# Access Compliance Report

## Public Rights-of-Way

### (Curb Ramps)

Intersection ID: 4877	Main Street: GRANARD_LN	Cross Street: HARRINGTON_WOODS_RD	Location: W
ADA ID: 1DD41FB8051D	Ramp Type: Perp	Initial Pass/Fail: Fail	Overall Compliance: No
Severity Score: 12.5			
Codes/Mitigation Info/Possible Solution		Field Measurements/Component Compliance

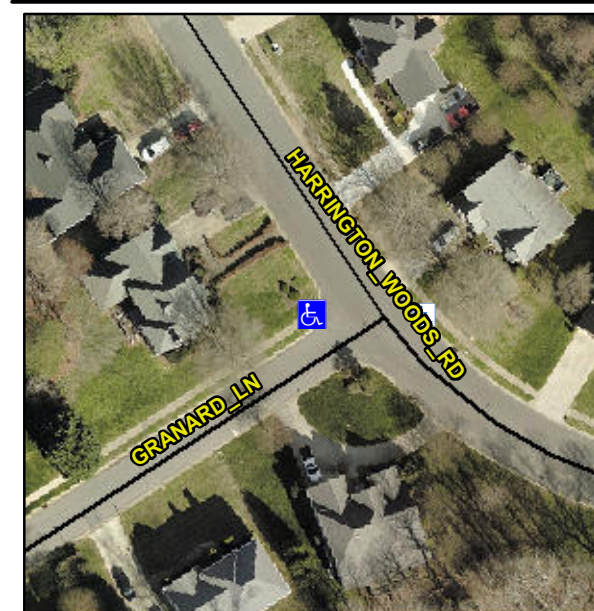
**R304.5.3**

Compliance	Description	Data	Compliance	Description	Data
N/A	Ramp Length (in)	38.0	Yes	Ramp Slope (%)	8.0
Yes	Ramp Width (in)	48.0	No	Ramp XSlope (%)	5.5
N/A	Flare Type LT	N/A	N/A	Flare Type RT	N/A
N/A	Flare Slope LT (%)	N/A	N/A	Flare Slope RT (%)	N/A
N/A	Flare Traversable LT?	N/A	N/A	Flare Traversable RT?	N/A
N/A	Landing Length (in)	N/A	N/A	DWS Provided?	N/A
N/A	Landing Width (in)	N/A	N/A	DWS Contrast?	N/A
N/A	Landing Slope (%)	N/A	N/A	DWS Length (in)	N/A
N/A	Landing X Slope (%)	N/A	N/A	DWS Full Width?	N/A
N/A	Landing Curb? (Y/N)	N/A	N/A	DWS Offset (in)	N/A
N/A	Shared Landing?	N/A			
N/A	Gutter Ponding?	N/A	N/A	Gutter Slope (%)	N/A
N/A	Gutter Lip Ht (in)	N/A	N/A	Gutter X Slope (%)	N/A
N/A	Painted X Walk1?	No	N/A	Painted X Walk2?	N/A
	X Walk 1 Direction	To SE		X Walk 2 Direction	N/A
N/A	X Walk 1 Width (in)	N/A	N/A	X Walk 2 Width (in)	N/A
	X Walk 1 Slope (%)	5.2		X Walk 2 Slope (%)	N/A
	X Walk 1 X Slope (%)	4.7		X Walk 2 X Slope (%)	N/A

**Remove & Replace Entire Ramp.**
